PHASE 1 SCHEMATIC DESIGN

NSW DEPARTMENT OF
EDUCATION

NORTH SYDNEY PUBLIC
SCHOOL

SEC. 4.55 MODIFICATION ITEMS

1 SECTION
BUILDING J - SECTION
SCALE: 1:100

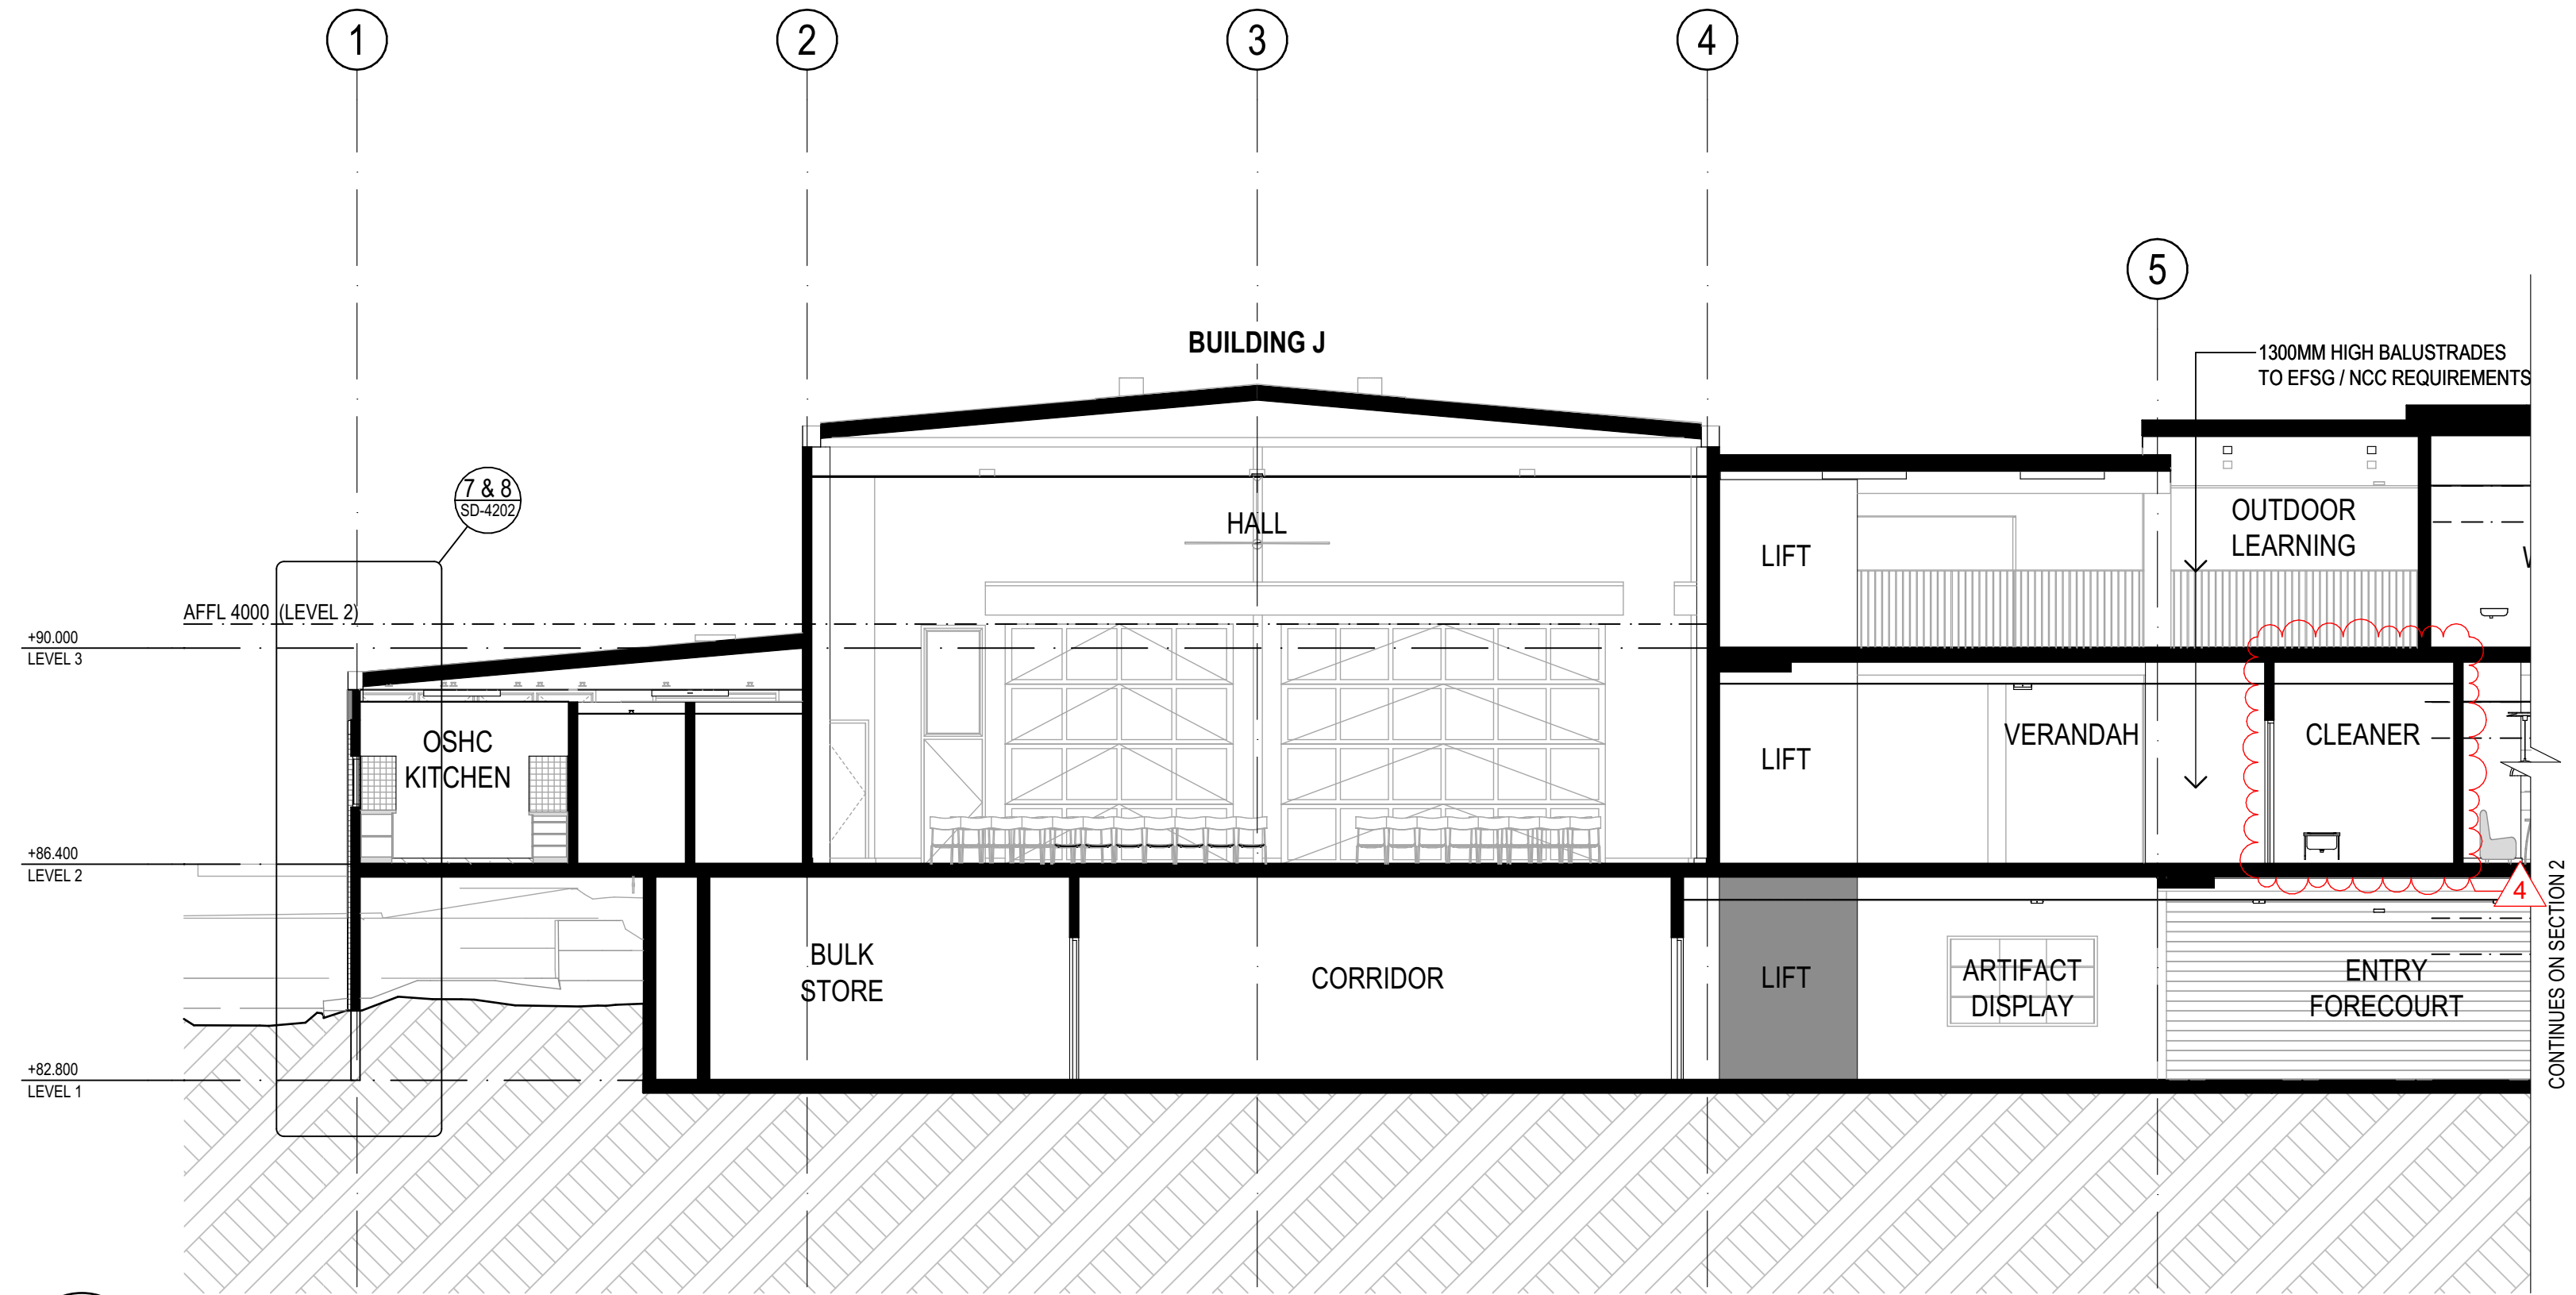
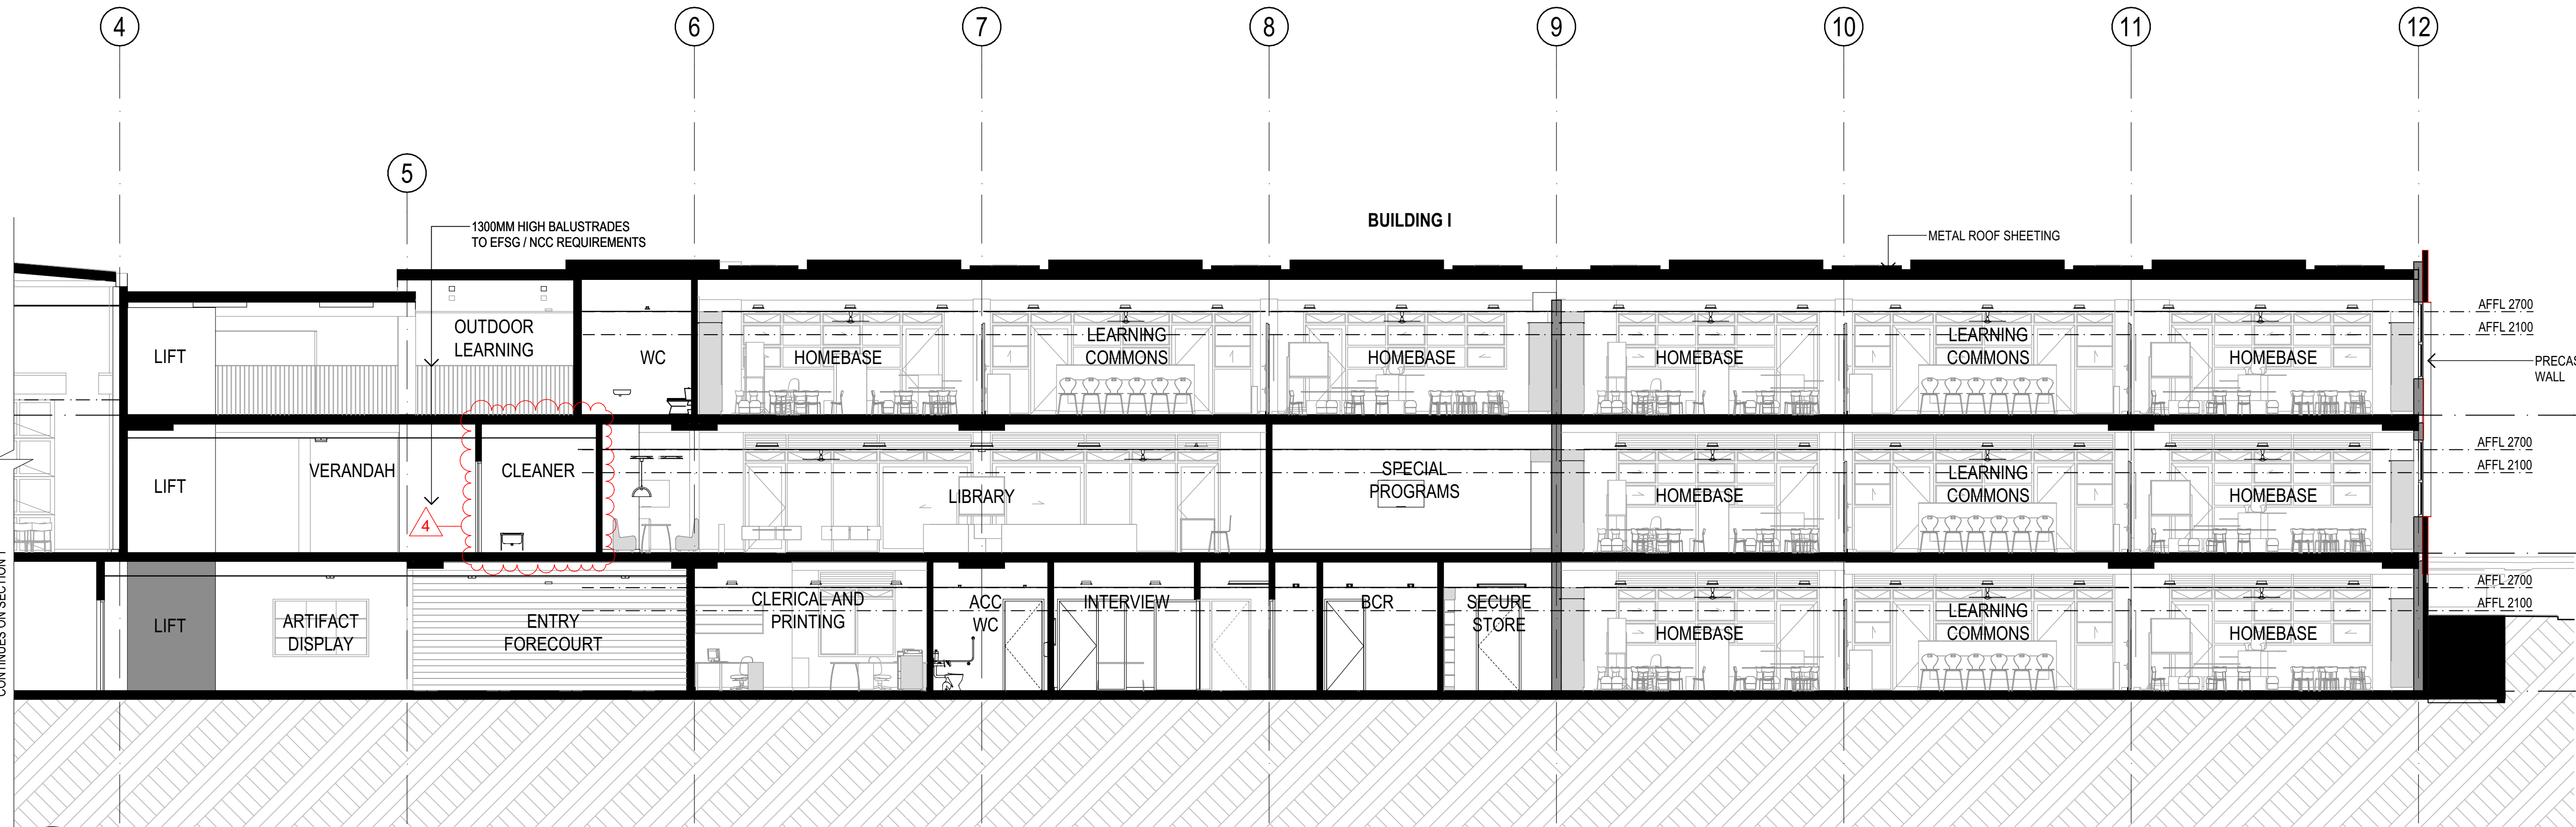
- ENTRY RAMP RECONFIGURATION TO BE 1:15, ADDITIONAL SLAB TO ACCESS PLANT ROOM
- HYDRANT BOOSTER LOCATION
- HERITAGE FENCE TEMPORARY REMOVAL
- ADDITIONAL CLEANER'S CUPBOARD
- LIBRARY ENTRY DOOR MOVED DUE TO CLEANER STORE BEING ADDED, NOW ALIGNS WITH LIFT
- WALL ALIGNMENT OF WC'S LEVEL 3
- WINDOW CHANGES TO BUILDING I SOUTH & EAST ELEVATIONS ON L1 / L2 / L3. WINDOWS INCREASED IN SIZE FOR COMPLIANCE WITH BCA PART F4 - LIGHT AND VENTILATION. FIXED GLAZED PANEL INTRODUCED TO LOWER SECTION OF L2 / L3 WINDOWS TO MEET MIN 1200MM SILL HEIGHT REQUIREMENT IN EFSG. LARGER OPENABLE AWNINGS INTRODUCED FOR NATURAL VENTILATION COMPLIANCE.
- LOUVERED DOORS CHANGE FROM SINGLE TO DOUBLE DOOR TO SUIT PLANT ROOM REQUIREMENTS.
